Woden Village DA RFI – List of Changes:

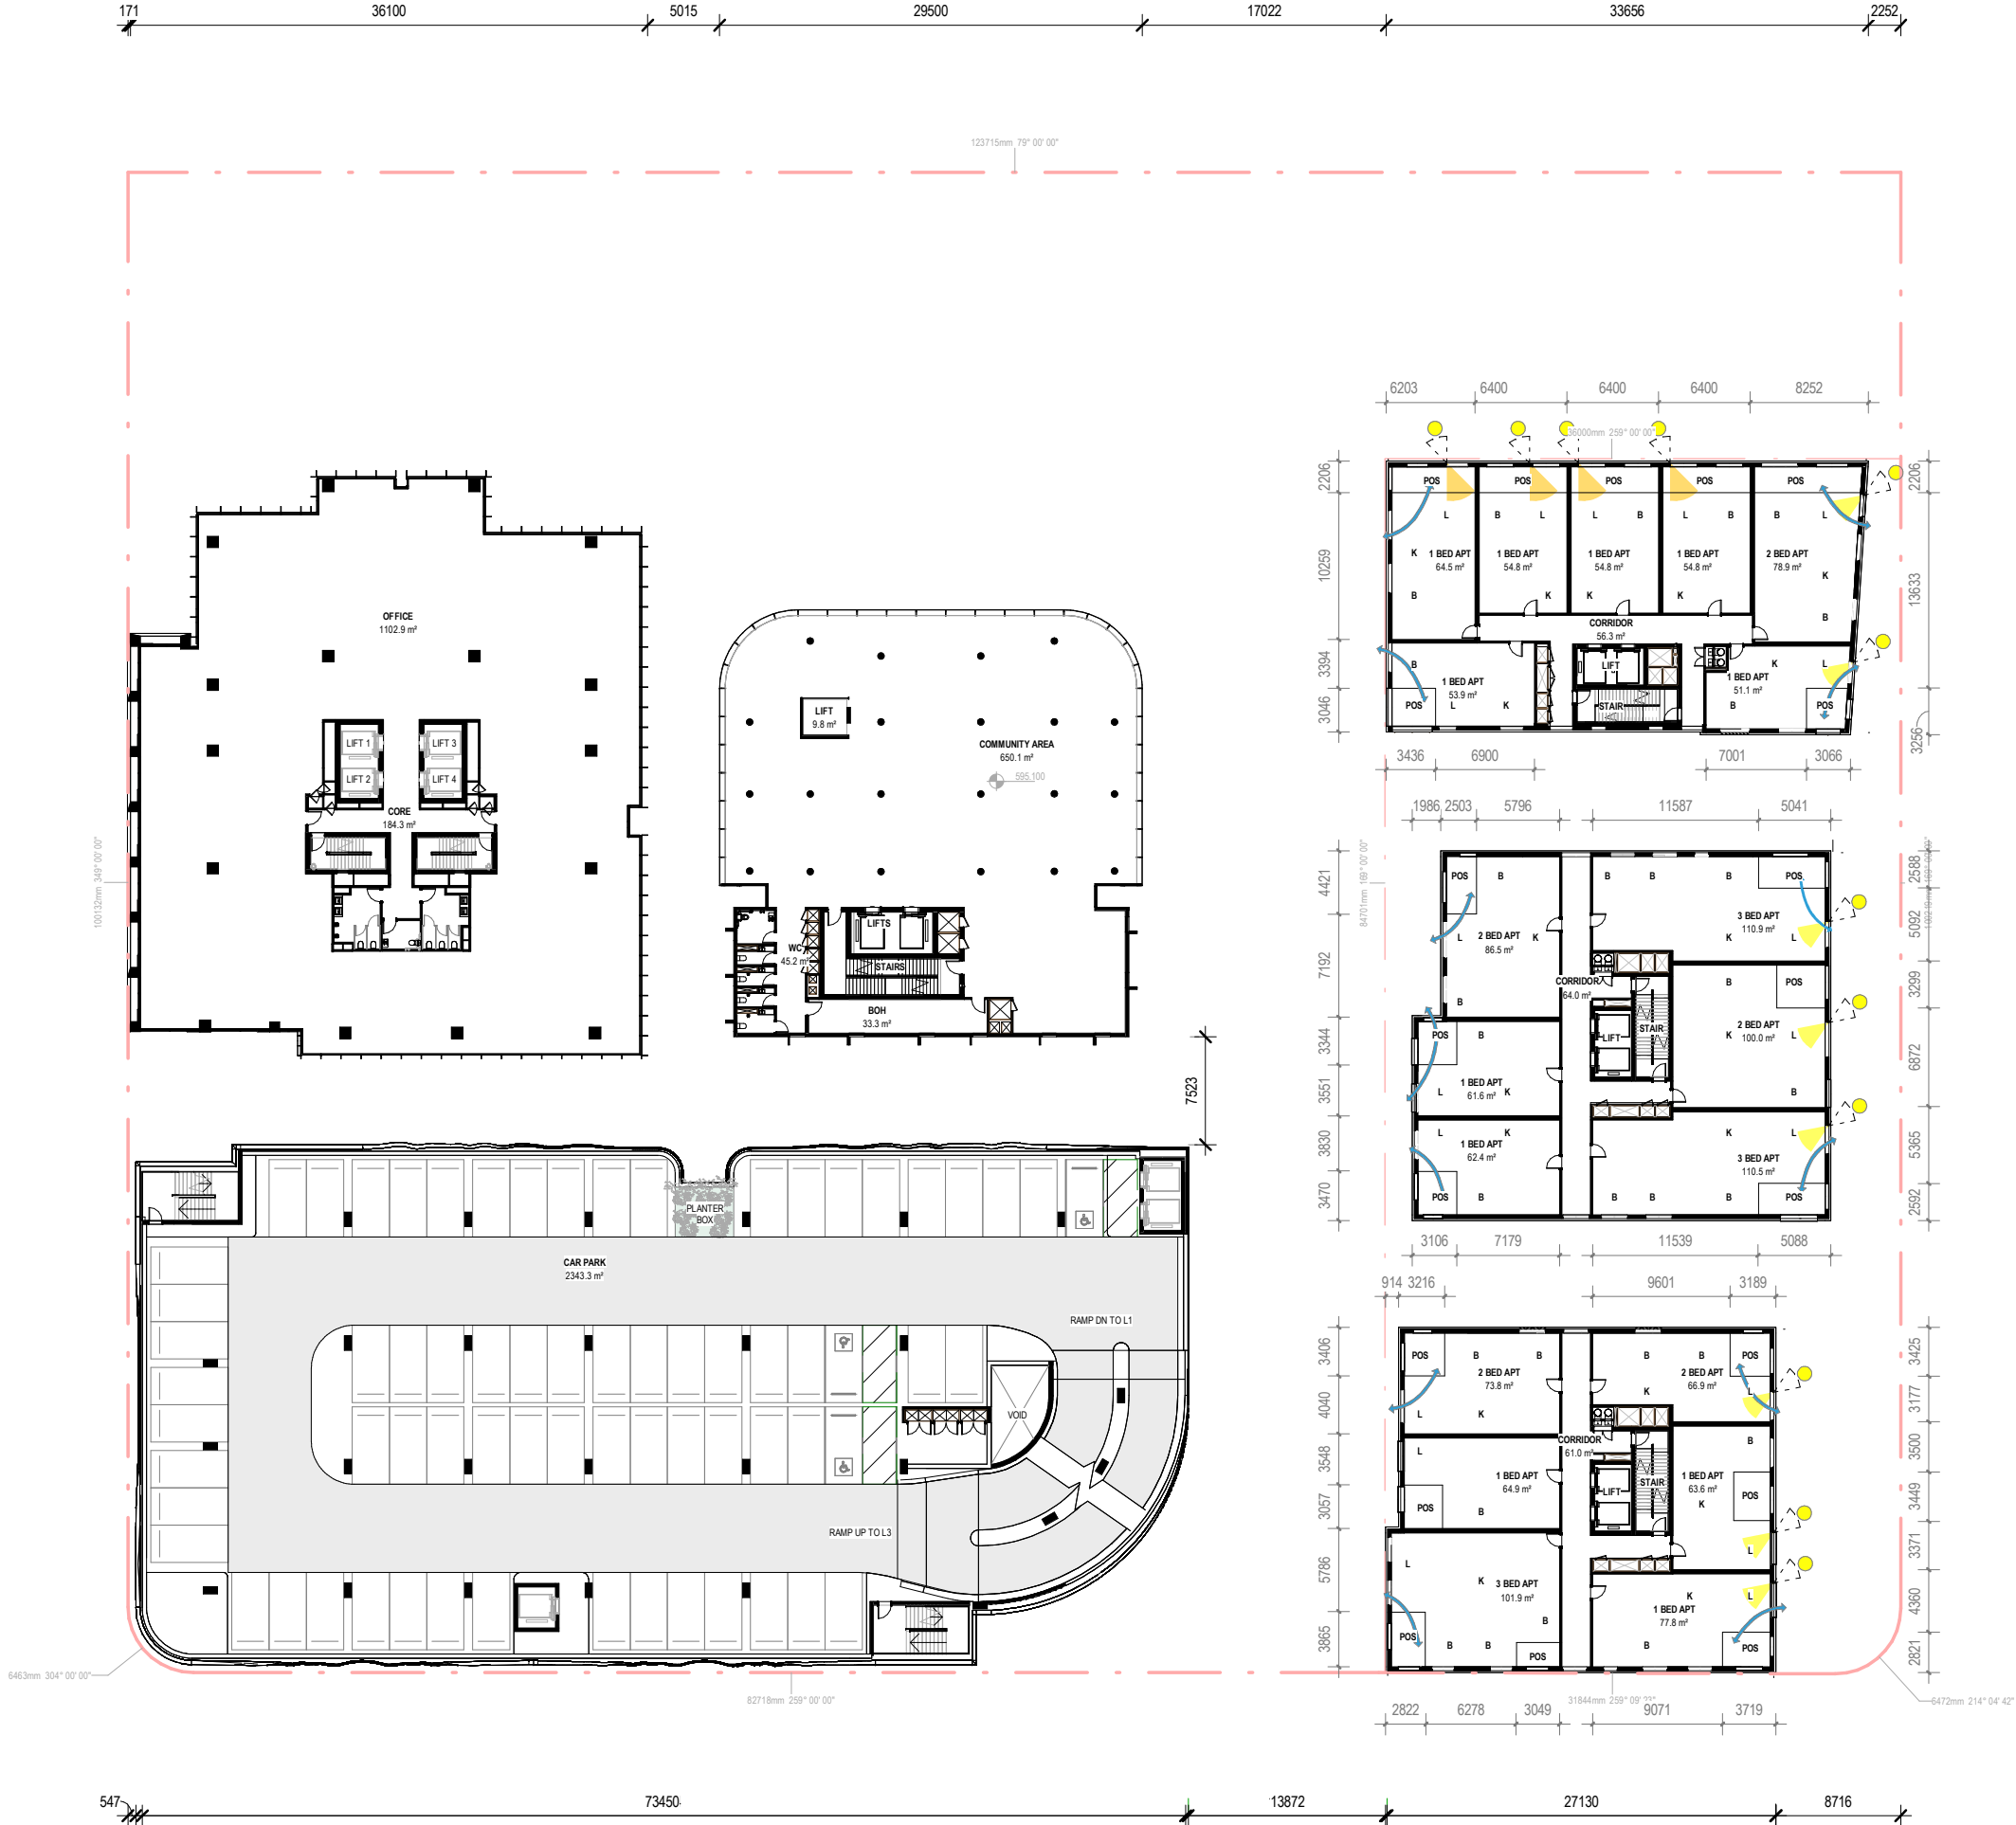
- A1. Driveways and verge crossings updated to match the Waste Management Ground Floor Plan.
- A2. Ground floor waste enclosures and waste storage updated.

- A3. Canopy above the waste collection zone removed.
- A4. Carpark link design revised.
- A5. Residential building link height adjusted.
- A6. Apartment layouts revised to improve functionality.

- A7. Development Schedule for the Community Building revised.
- A9. Northern Residential Tower upper levels revised (façade, internal planning, and apartment mix updated).

- A10. Carpark roof landscape updated.
- A11. Roof plant area setbacks updated, and solar panel orientation adjusted.
- A12. Carpark pedestrian link updated, services relocated.

- A13. Dwelling typology plans provided.
- A14. Floor-to-ceiling heights added.
- A15. Residential corridor widths adjusted to meet the minimum requirement of 1540 mm.

- A16. Ground floor amenity space converted to a residential lobby.
- A17. Privacy screen details provided.
- A18. Additional elevations added.
